SERVICE BULLETIN

No. 703

Piper Aircraft Corporation

Subject: Aileron Balance Weight Attachment
Inspection and Rework

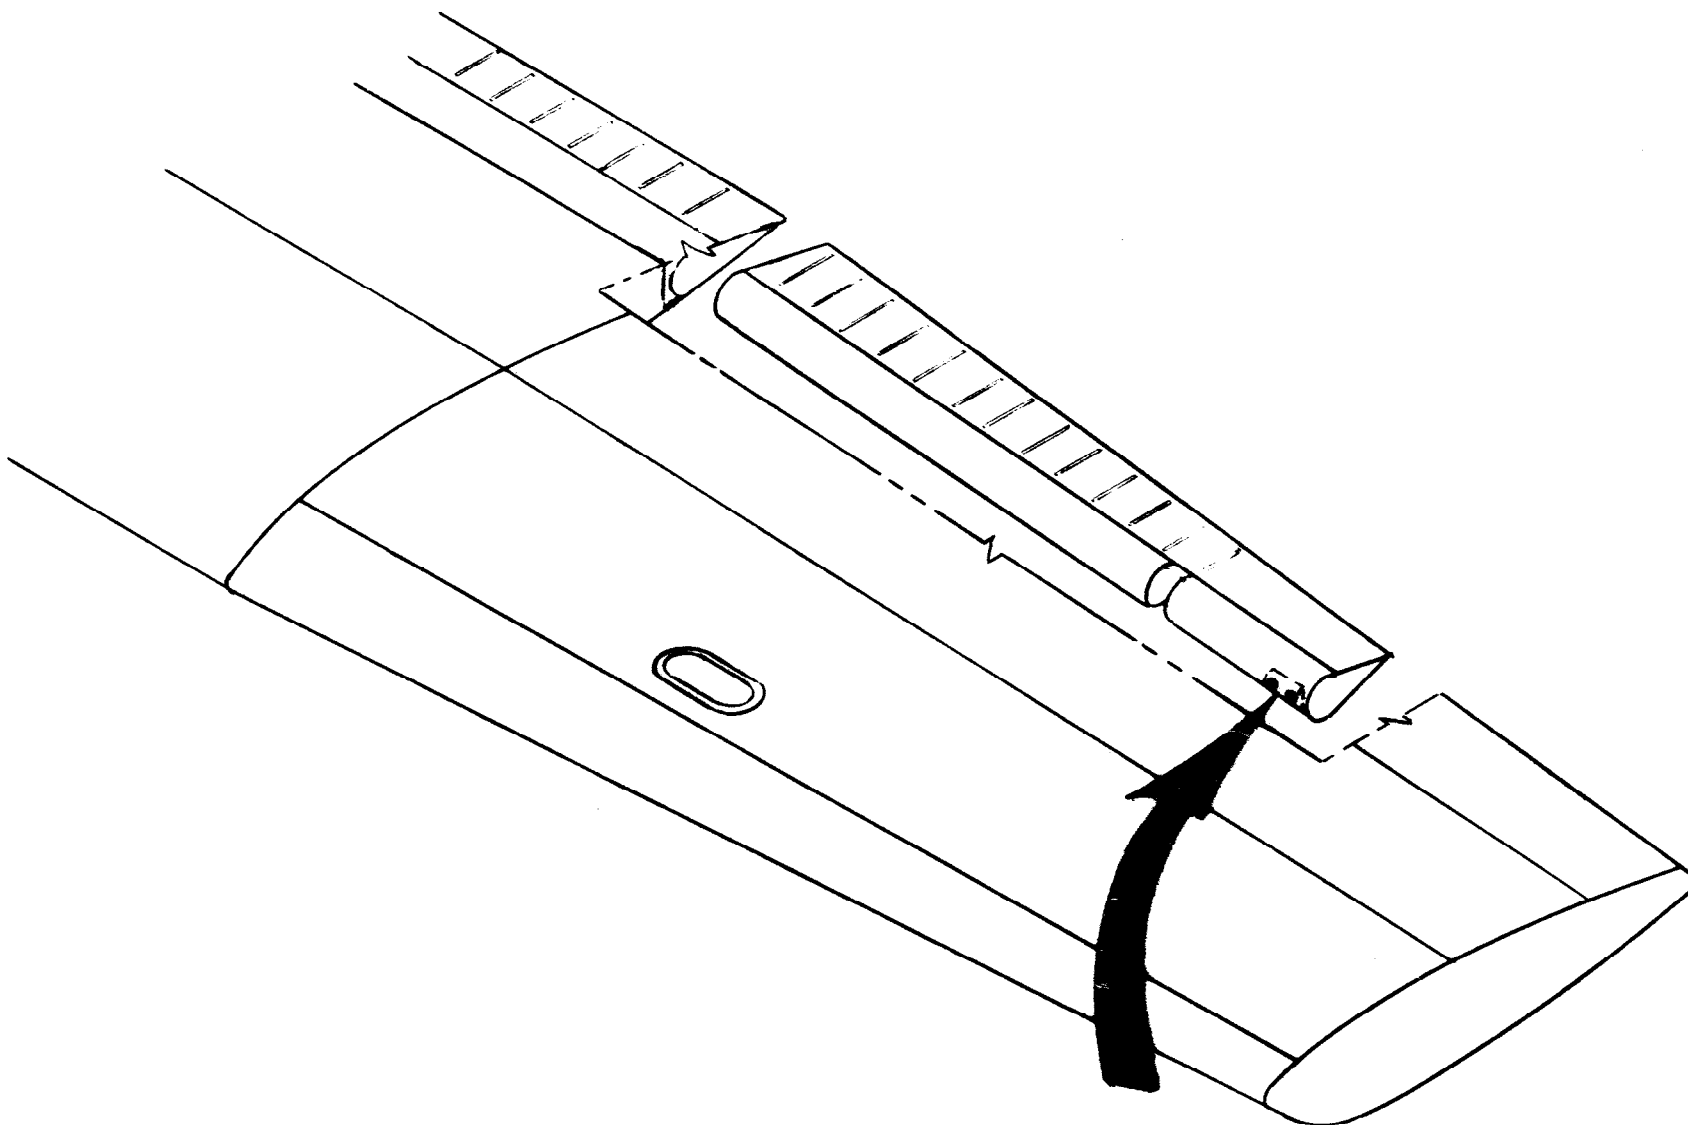
1. Check the left and right aileron outboard leading edge skins for cracks near the balance weight attachment screws.
 2. If skin is cracked around either balance weight attach screw, proceed to PART II of this Service Release.
 3. Make logbook entry of each inspection.
-

INSPECT IN THIS AREA FOR CRACKS
ON LEFT AND RIGHT AILERONS.

1. All instructions necessary to reinforce the aileron outboard leading edge skin are included in the Aileron Rework Kit, Piper Part Number 764 091V.
-
